15-BSTD-01

TN # 75481

2016 Building Standards Update

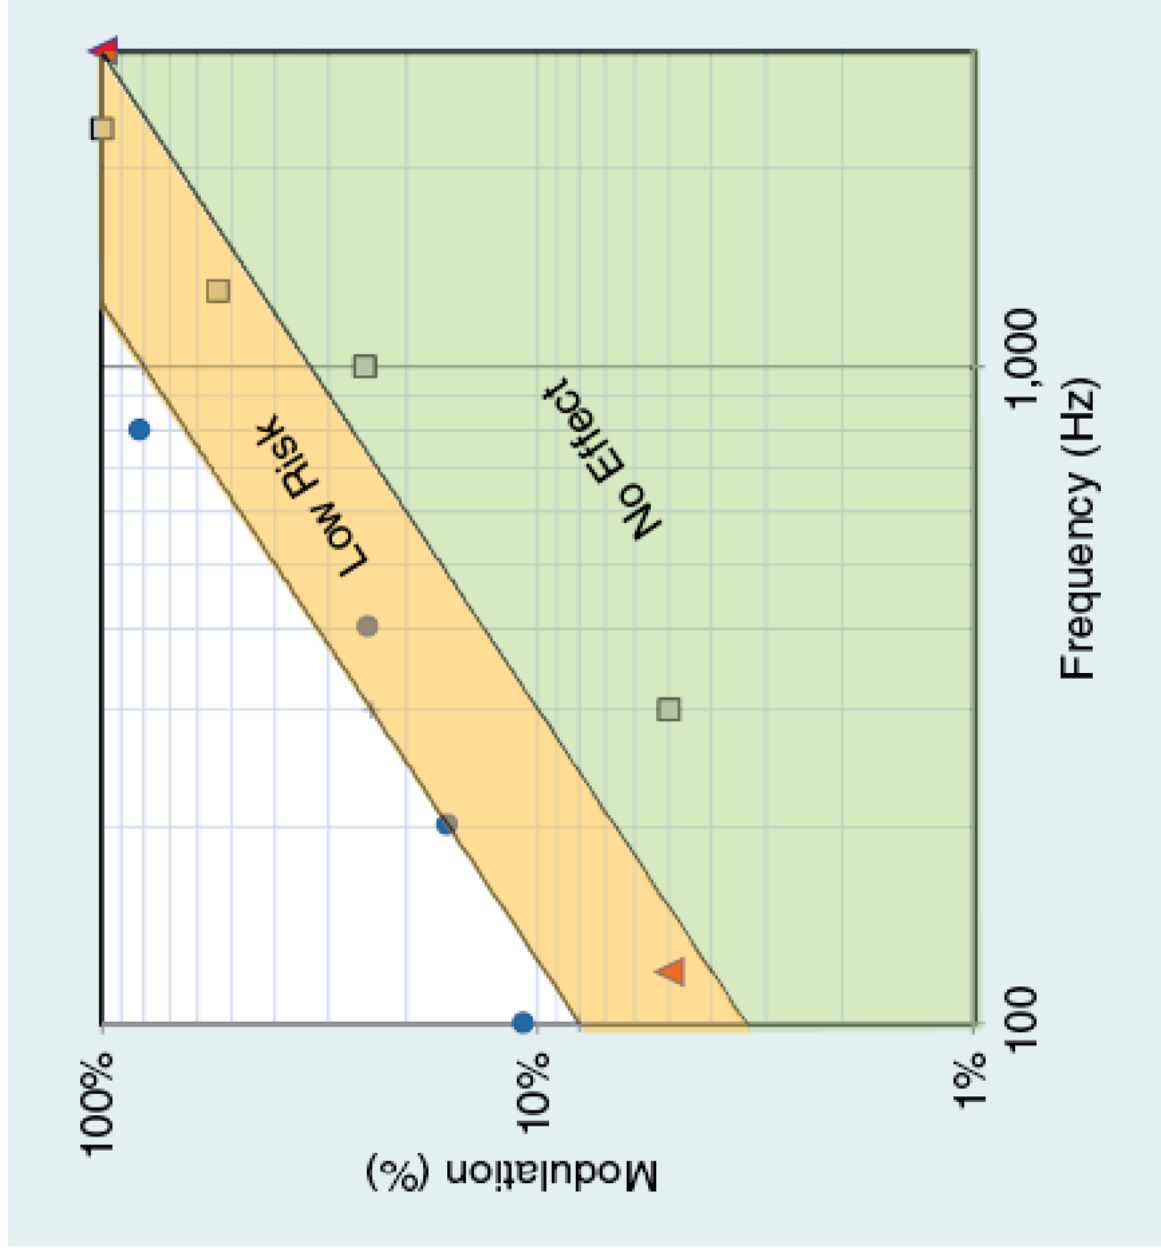
I have researched the effects of lighting flicker on headache and ocular motor control for the last 30 years. The standards that you are proposing are nowhere near stringent enough to reduce the symptoms induced by flicker. It is a major innovation, however, to insist on the measurement of flicker, and it can only be hoped that over time the criteria will become more stringent.

The attached graph shows the no-effect region for flicker expressed as a joint function of flicker frequency and modulation depth. The curve does justice to the available evidence from several studies of the stroboscopic effect (the intermittent appearance of a moving object under flickering illumination) and the phantom array (the appearance of pattern during a saccade). These studies used a variety of waveform shapes, and yet the characterisation of flicker in terms of percent modulation provides a reasonable fit. It is acknowledged that this approach takes insufficient account of the effects of waveform shape and it is hoped that in the future it will be possible to use the attached curve together with waveform characterisation in terms of Fourier components. The curve has been published in an article by Prof Brad Lehrman (Northeastern U) and myself in IEEE Power Electronics Vol 1 No 3 Sept 2014, and it forms the basis of the forthcoming IEEE1789 standard.
